PROJECT
APT Residential
Meadowbank

LOCATION
1-20 Railway Rd & 50
Constitution Rd
Meadowbank NSW 2114

REV	DATE	DESCRIPTION	DN	AP
09	22.11.24	S4.55 Amendment		
08	07.08.24	Section 4.55	MF

- MODIFICATIONS TO SECTION 4.55 APPLICATION
1. ENCLOSURE TO LIFT LOBBIES REMOVED.

SHEET TITLE
PLAN - BASEMENT 02

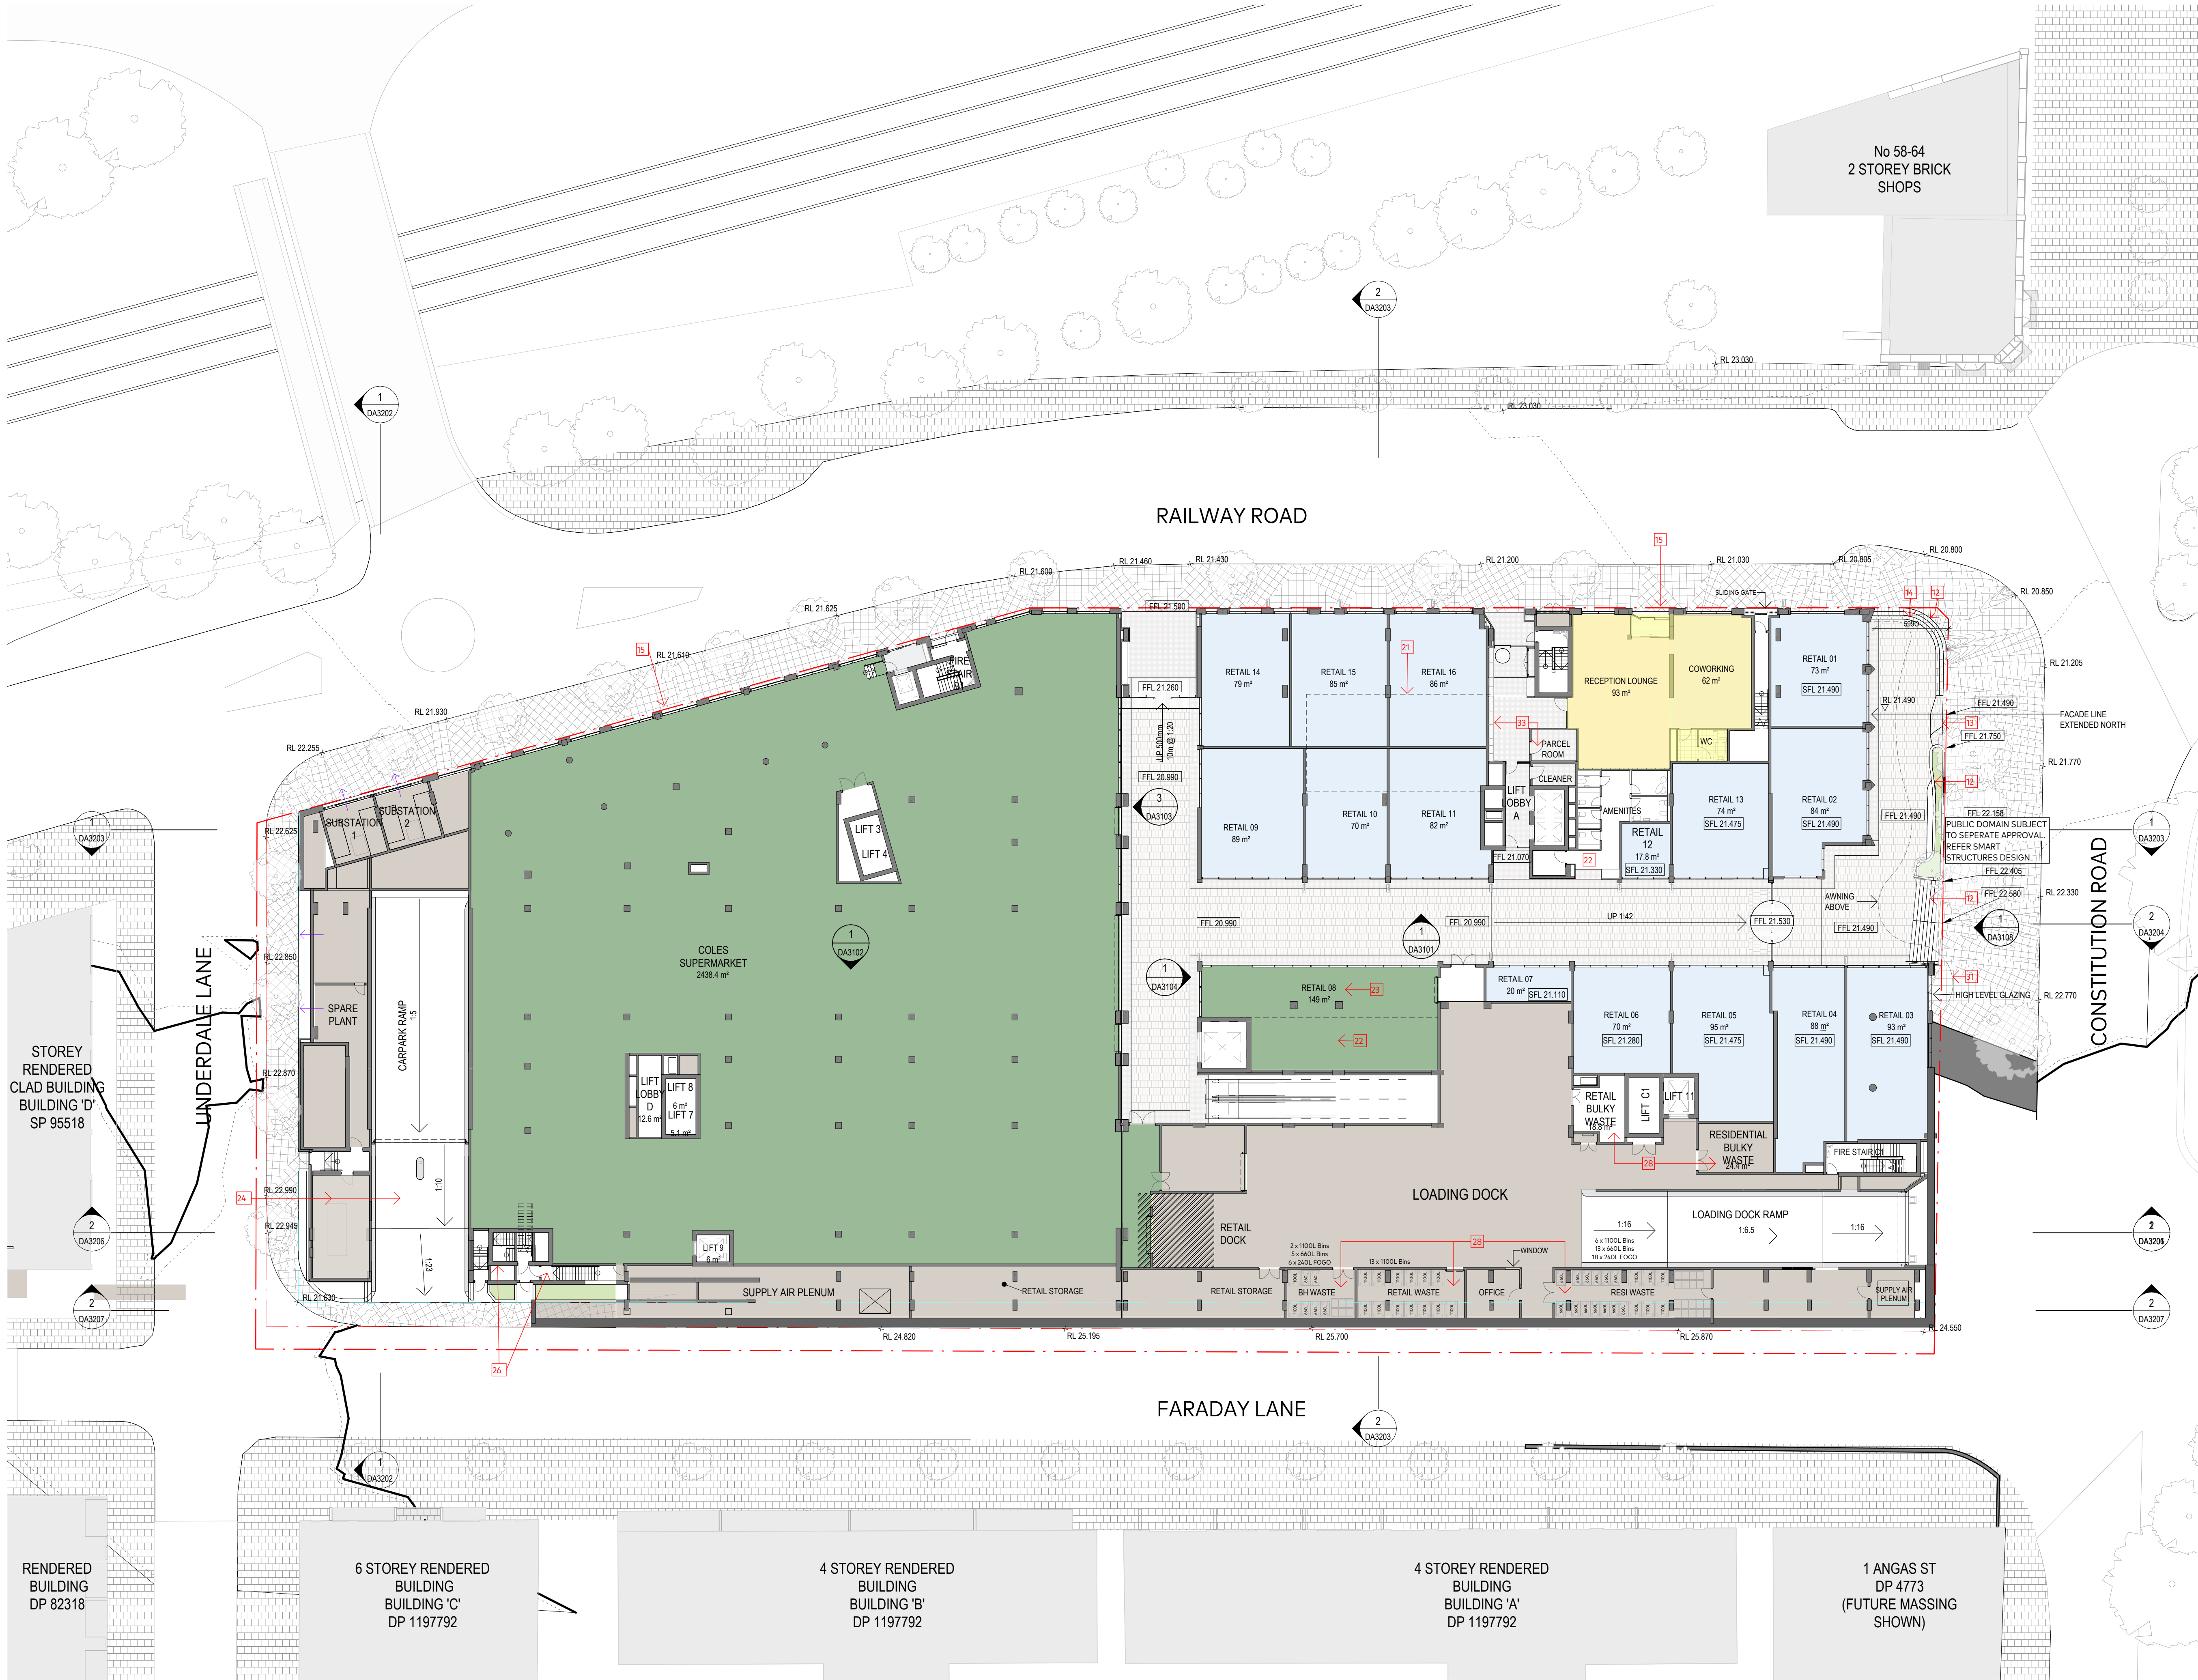
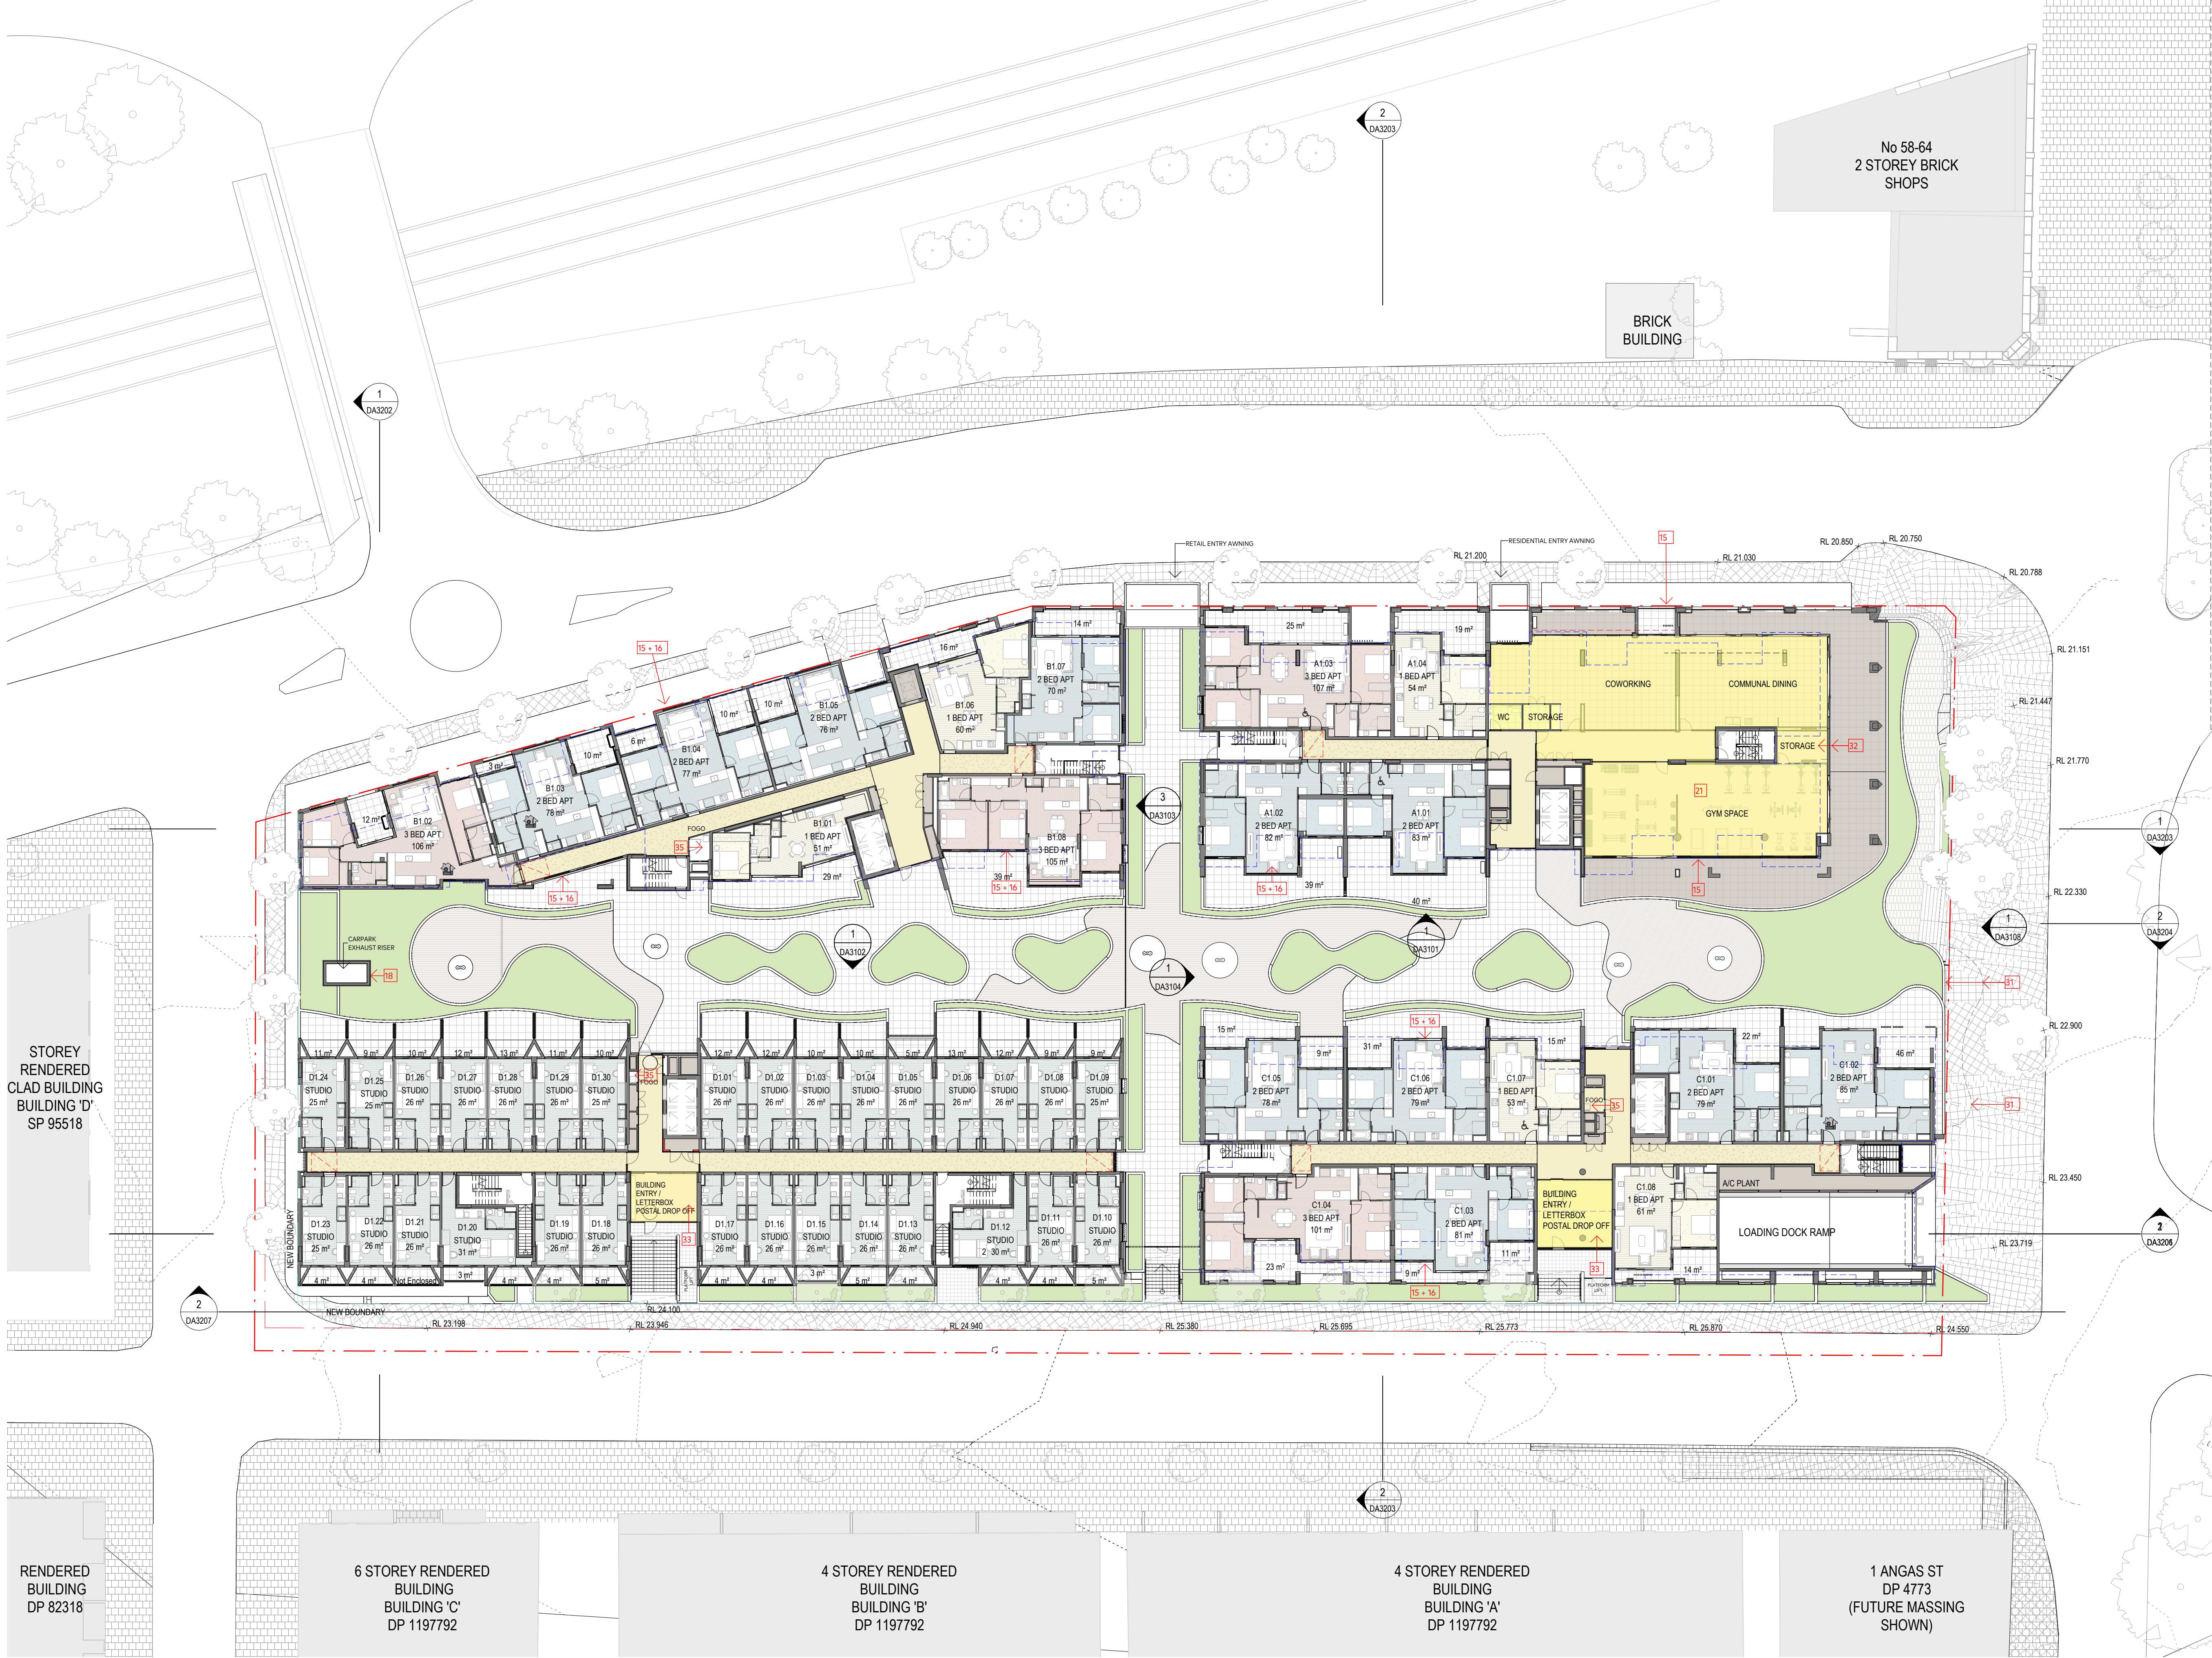
- MODIFICATIONS TO SECTION 4.55 APPLICATION
- ENCLOSURE TO LIFT LOBBIES REMOVED.
 - STRUCTURAL GRID COLUMNS CHANGED AND SUPPORT CONCRETE BLADE WALLS ADDED.

- RAMP CENTRE KERB ADDED AND NEW ENTRY KERB TO AIR LOCK.
 - STORAGE AREA ADDED.
 - GREASE ARRESTOR AND PUMP ROOM RELOCATED.
 - COMMS ROOM RELOCATED.
 - BUILDING D LAUNDRY REMOVED AND PUMP ROOM LOCATED.

- ENTRY AREA STAIRS MAINTAINED. NEW STAIR ENTRY ADDED WITH LANDSCAPING ADDED WITH PUBLIC SEATING.
 - NEW DISABILITY ENTRY.
 - SETBACK REDUCED TO ENABLE COLUMNS TO ALIGN STRUCTURAL REQUIREMENT.

- GENERAL FACADE ALIGNMENT MODIFICATIONS (TO FULL LENGTH OF BUILDING) DUE TO STRUCTURAL GRID CHANGE / COORDINATION AND REVISED APARTMENT LAYOUTS.
 - APARTMENT LAYOUTS CHANGED TO ALL LEVELS OF ALL BUILDING A, B, C AND LEVEL 5+ 6 OF BUILDING D. (REFER TO DASHED LINE FOR PREVIOUS CONFIGURATION)

- POP OUT GLAZING REMOVED (SHOWN DASHED IN RED) AND REPLACED AND RELOCATED WITH VERTICAL STRIP GLAZING INCORPORATING PRIVACY SCREENS.
 - ROOF & LEVEL 1 SERVICES ADDED.

- ROOF PROFILE MODIFIED TO SUIT APARTMENT LAYOUT CHANGES.
 - LANDSCAPED AWNING PROFILE MODIFIED. DUE TO STRUCTURAL REQUIREMENTS.
 - GYM RELOCATED TO LEVEL 1.

- AMENITIES RELOCATED.
 - COLES LIQUORLAND ADDED.
 - RAMP GRADIENTS ADJUSTED AND SERVICES ROOMS RECONFIGURED.
 - OVERALL BUILDING HEIGHT INCREASED. DUE TO NEED TO INCREASE FLOOR TO FLOOR HEIGHTS FOR BUILDABILITY AND INCREASED TOLERANCE.

- STAIR RECONFIGURED. NO CHANGE TO STREET EGRESS POINT.
 - LAUNDRY AREA FOR BUILDING D REMOVED. INDIVIDUAL LAUNDRY SPACE ADDED WITHIN STUDIO APARTMENTS.

- WASTE BINS RE-ORGANIZED.
 - FACADE SCREENS REMOVED TO INCREASE LIGHT QUALITY INTO APARTMENTS. THIS IS IN RESPONSE TO THE UDPP'S COMMENTS AND HAS BEEN REVIEWED AND ASSESSED BY ESD CONSULTANT.

- SMALL BALCONY'S REMOVED AND APARTMENT GLAZING MOVED OUT TO BALCONY EDGE. IN RESPONSE TO UDPP'S COMMENTS.
 - ENTRY AWNING REDUCED TO PUBLIC DOMAIN OVERLAP.

- ADDITIONAL STORAGE ROOM ADDED AND FACADE LINE MOVED.
 - MAIL AREAS ADDED TO EACH BUILDING ENTRANCE.
 - RESIDENTIAL TRAFFIC CONTROL AMENDED DUE TO TRAFFIC ADVICE.

- FOGO BINS ADDED.
 - BUILDING D BULKY WASTE ADDED.
 - PRIVACY SCREEN, SERVICE SCREENS AND GLASS BALUSTRADES AND SOLAR PANELS ADDED.

Overall Increase in Building Height - 540mm

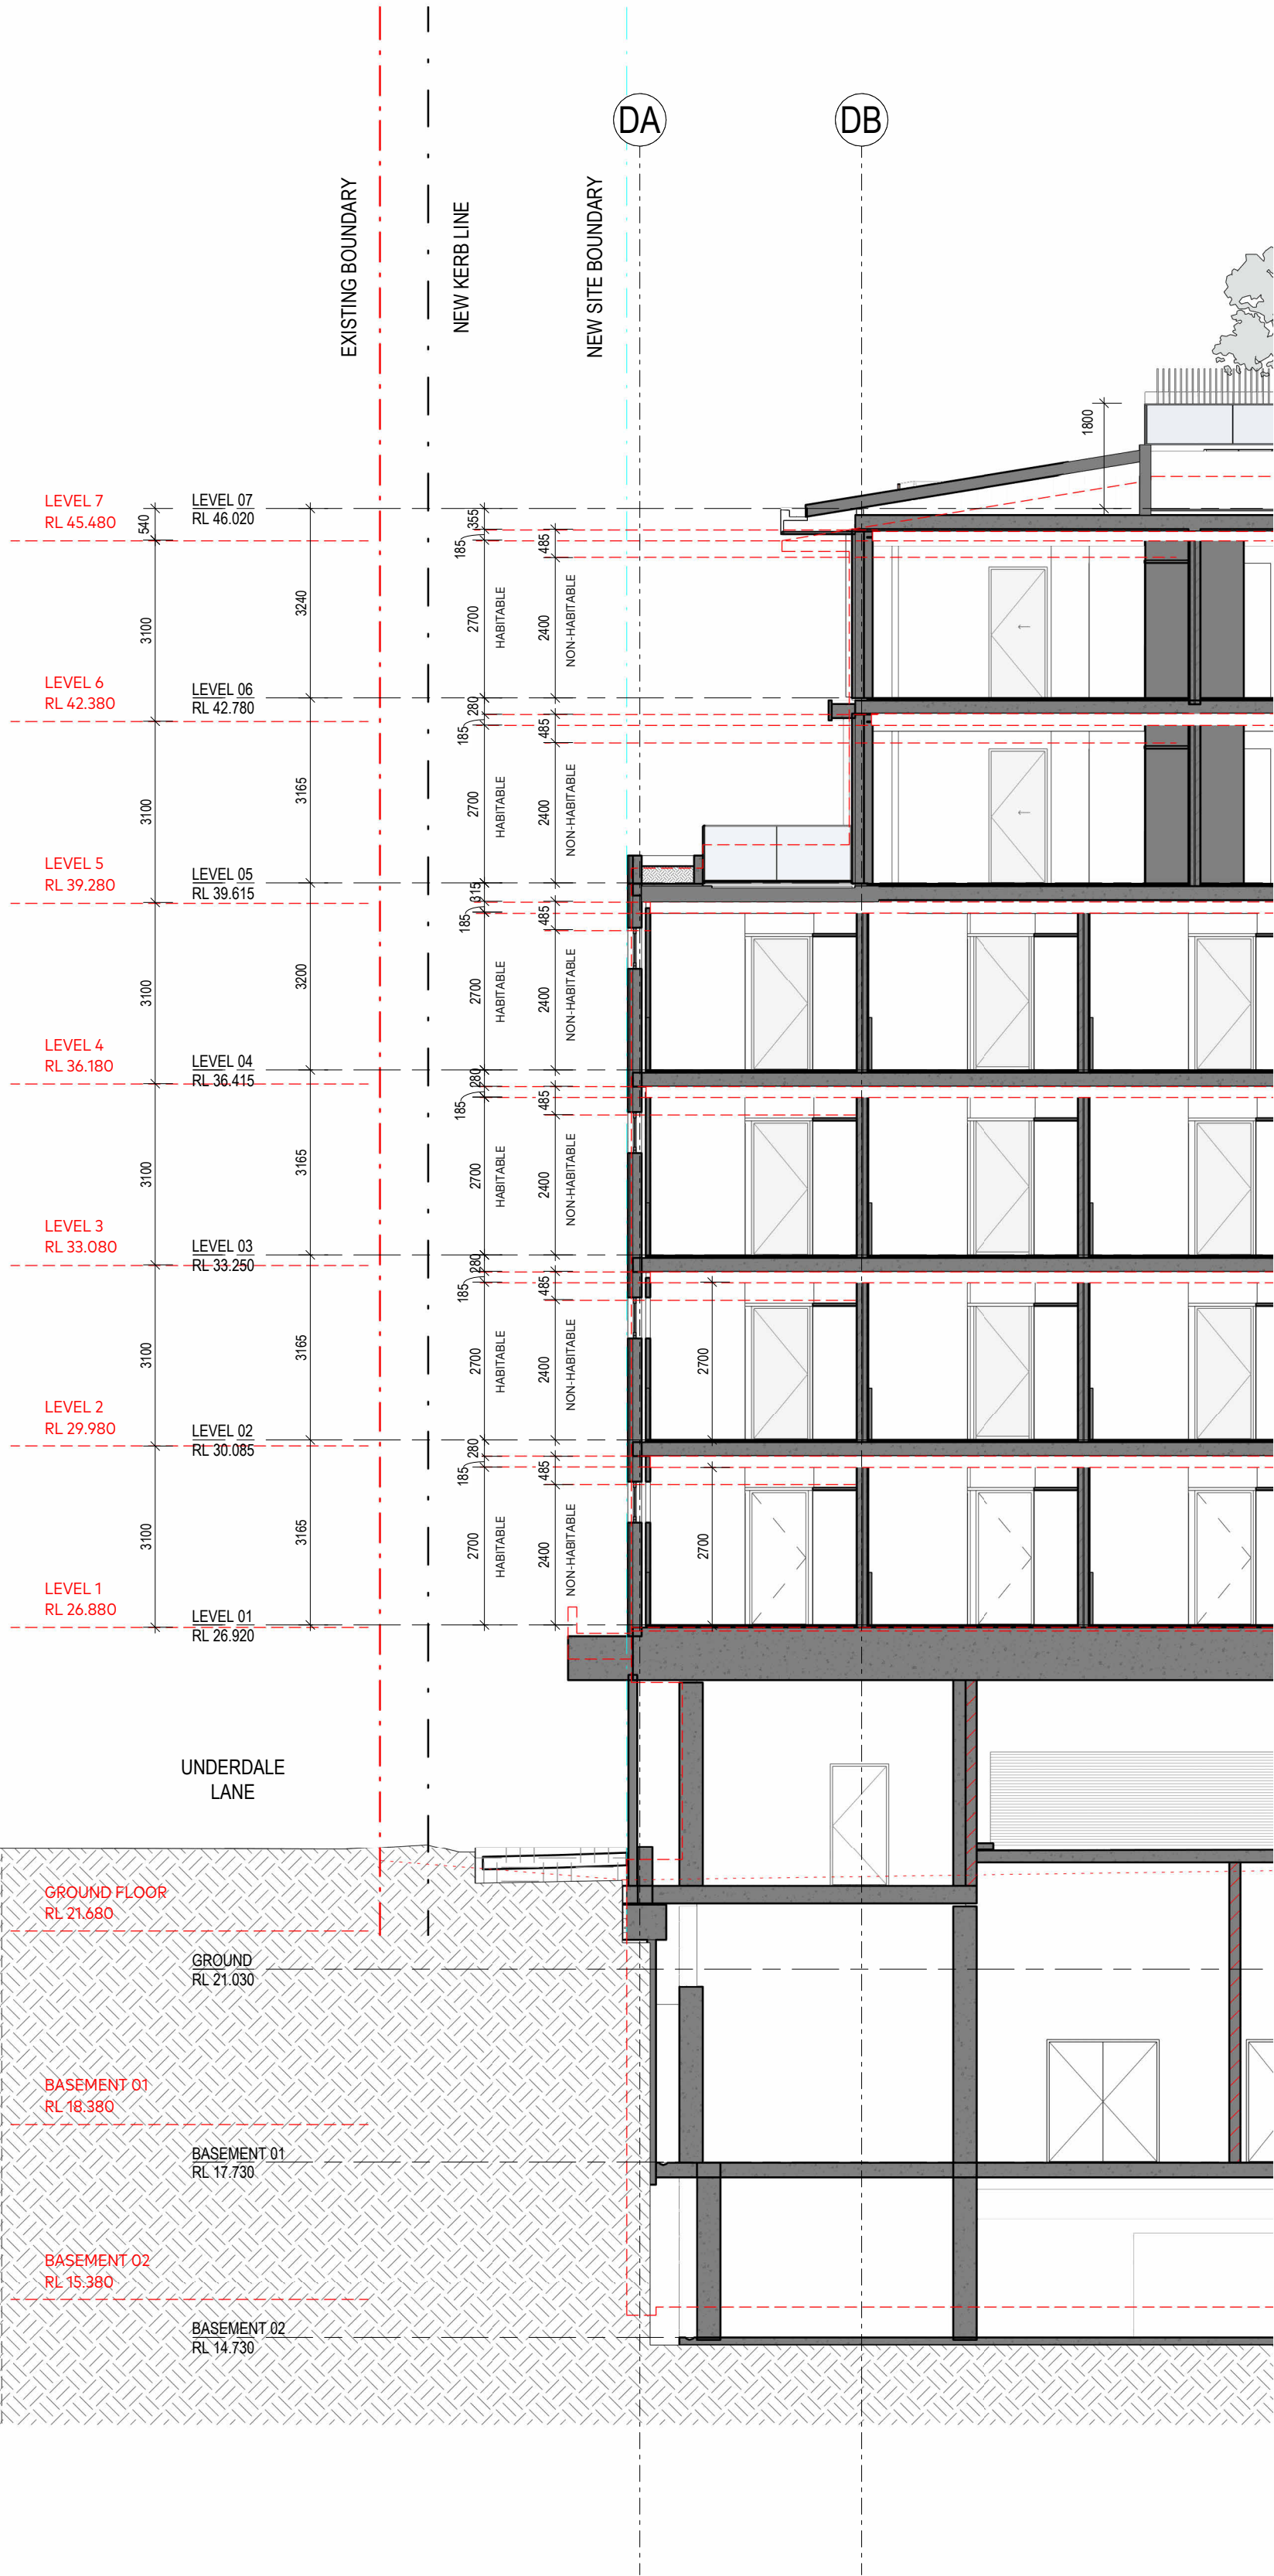
The non-typical levels 4 and 6 require additional depth, due to increased slab set-downs for accessibility requirements and insulation that required to the levels above them, which are terraced floors and rooftops. This increase is an additional 70mm total.
